ADA Compliance Program

ADA ACCESSIBILITY SURVEY FOR PARK FACILITIES

Date: 3-14-05	Estimated Cost:
Facility: Orchards Park	Department Notified:
Survey by: Jim Sandlin, Steve Duh, Dan George	Date of Notification:

Date: September 5, 2006
Facility: Orchards Park
Item: Estimated Cost for Park Renovations

Item 14

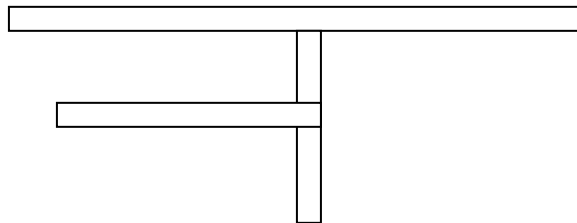
14. Shelter Area – Picnic Tables – The shelter area is equipped with numerous pedestal picnic tables. Two of the tables have been vandalized as shown in the photo to the left. It is recommended that that horizontal support bar that use to support the seat, be cut off at the vertical base to provide wheelchair accessible seating on the two vandalized tables. Additional wheelchair seating should be added to two tables on the west side of the shelter and two tables on the east side of the shelter by cutting off half of the seat supports as shown below.

14. \$250
